Reference: Tijeras Club Townhouses

Subject: Tijeras Club Townhouses, FHA File No. 530,
Albuquerque, New Mexico

DRAINAGE STUDY

TIJERAS CLUB TOWNHOUSES

DWG No D-1

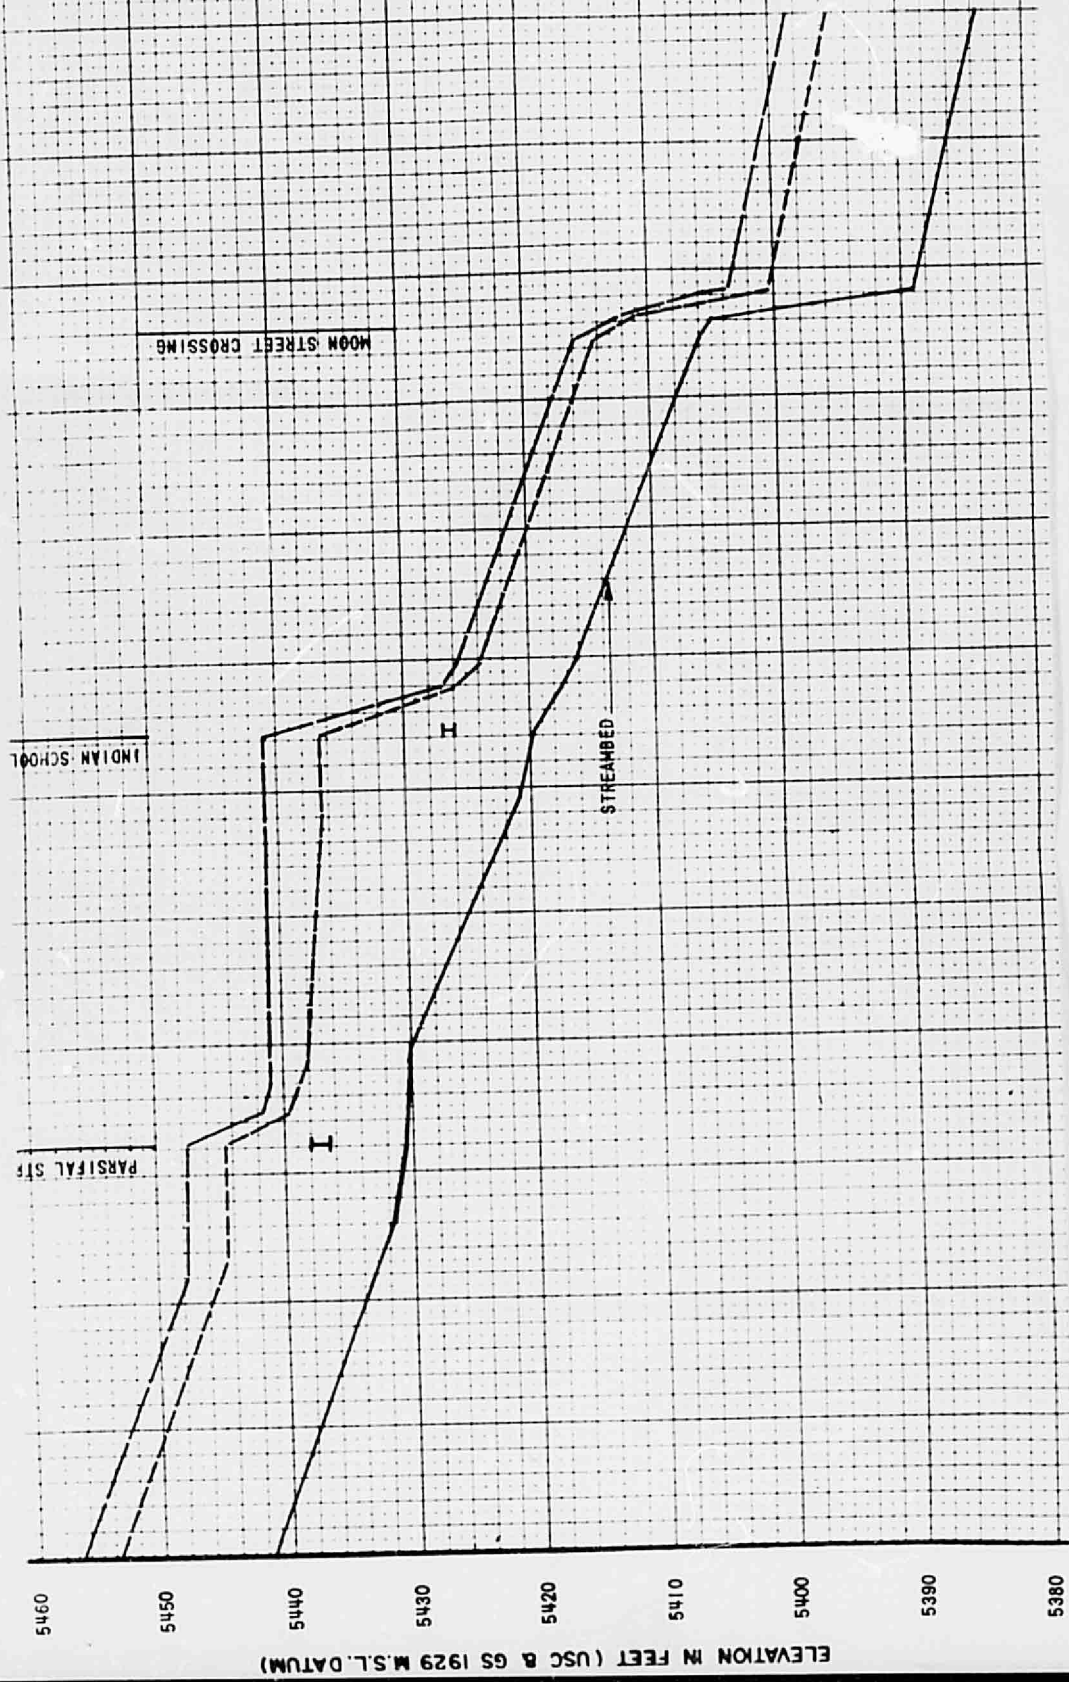
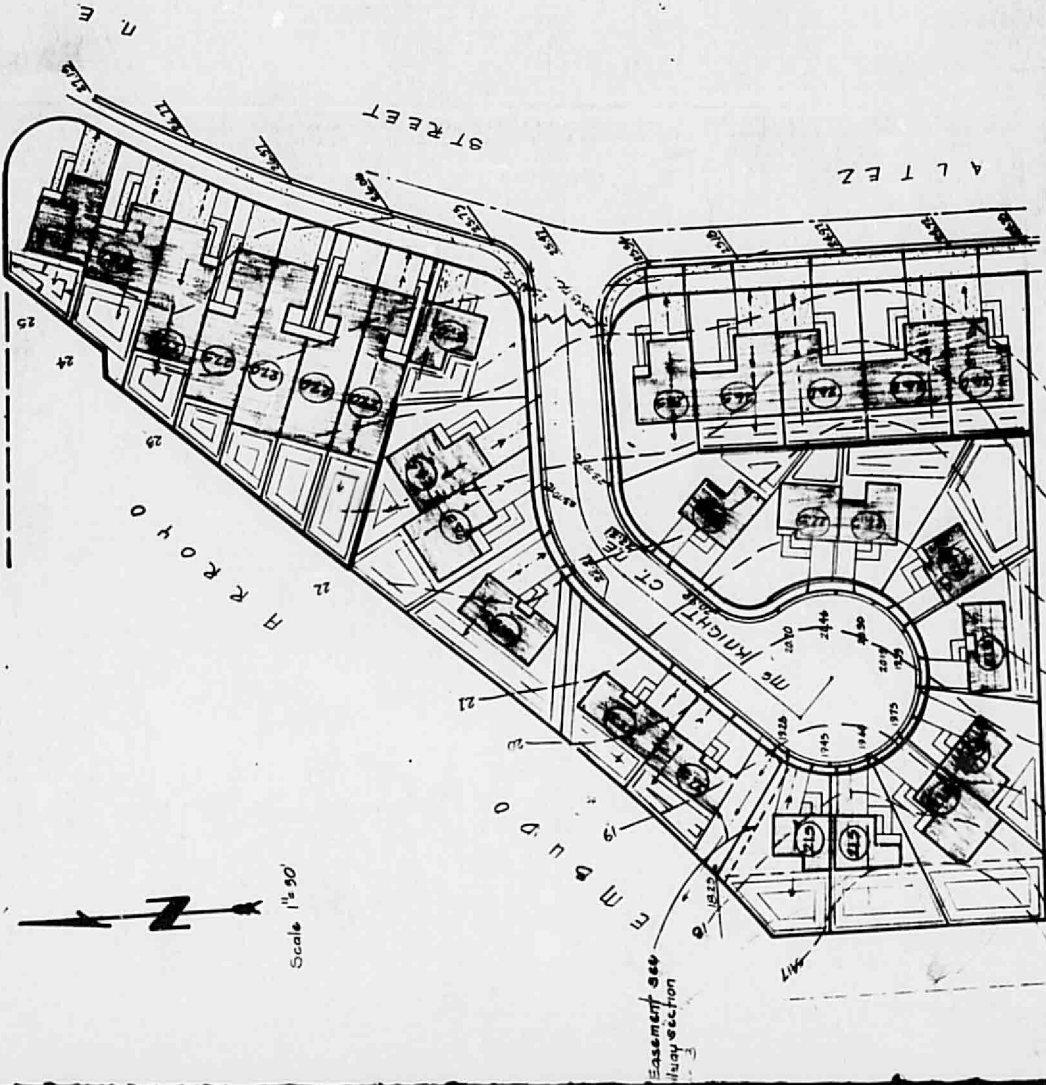
Our review of the neighborhood grading and drainage plan for the subject subdivision reveals that it is not acceptable. The plan proposes "ponding areas" on a number of the lots as close as five (5) feet from the buildings. FHA's requirement is that no water be ponded within fifteen (15) feet of the structure. In addition, the soils report for the subject subdivision recommends that positive surface water drainage be maintained and that the soils at and below the foundation elevations be kept dry.

Due to the size of lot in this development and the placement of the buildings, it may be necessary to find an alternative to ponding in order to maintain the structural integrity of the proposed units.

A review of the hydrologic data of the Embudo Arroyo System held on January 31, 1979 in the offices of the Albuquerque District of the U.S.C.E. with Mr. Boyd Lare of the Flood Plain Management Section, has lead to the conclusion that the flood hazard conditions indicated on the USCE studies have been reduced after the construction of the Embudo Dam. This reassessment will allow the City to permit the development of the parcel of interest. It is nevertheless recommended that a retention well, 3 ft. in height, be built along the north property line and the first 200 ft. south of Indian School Rd. along the channel. Regarding the offsite flow, it is requested that the runoff emanating from the east in excess of the storm sewer capacity be conveyed through the 20 ft. easement into the Embudo Arroyo. It is also recommended that the site grading plan be revised to remove the ponding areas. Direct discharge to the arroyo will be allowed through one single facility that will have collected all the runoff of the subdivision. It is requested that a letter of amendment to the drainage report be submitted incorporating the requirements above together with a revised site grading plan.

Consultants, Inc. has been hired by Bill Sanchez to revise the grading plan for the above referenced project to meet FHA MPS standards. One of the objections FHA had to the submitted plan was the potential presence of ponded runoff up to 1.5 ft. deep adjacent to some structures.

In light of the presence of the Embudo Arroyo adjacent to lots 14-27, we would like to request that these lots be allowed to drain directly into the channel by way of individual 3" pipes. The remainder of the lots would be ponded as provided for in the approved report, with the addition of underground gravel basins where required due to FHA grading requirements for open space and maximum pond depth of 0.5 ft.

- (1) Retention Wall: As per your request, a 3' high retention wall will be constructed along the north property line and first 200' south of Indian School Road along the channel of the proposed subdivision.
- (2) Offsite Runoff: The drainage study as submitted provides adequate facilities to handle offsite runoff emnating from the east which exceed the present condition. A concrete lined run-down between lots 14&15 will be provided with proper structure discharging into the Embudo Arroyo.
- (3) Onsite Ponding: The developer believes that the backyard ponding be retained as shown on the grading plan, since the backyards will be individually fenced and the drainage along the back lots will not be feasible.

Attached is a revised grading plan as requested.
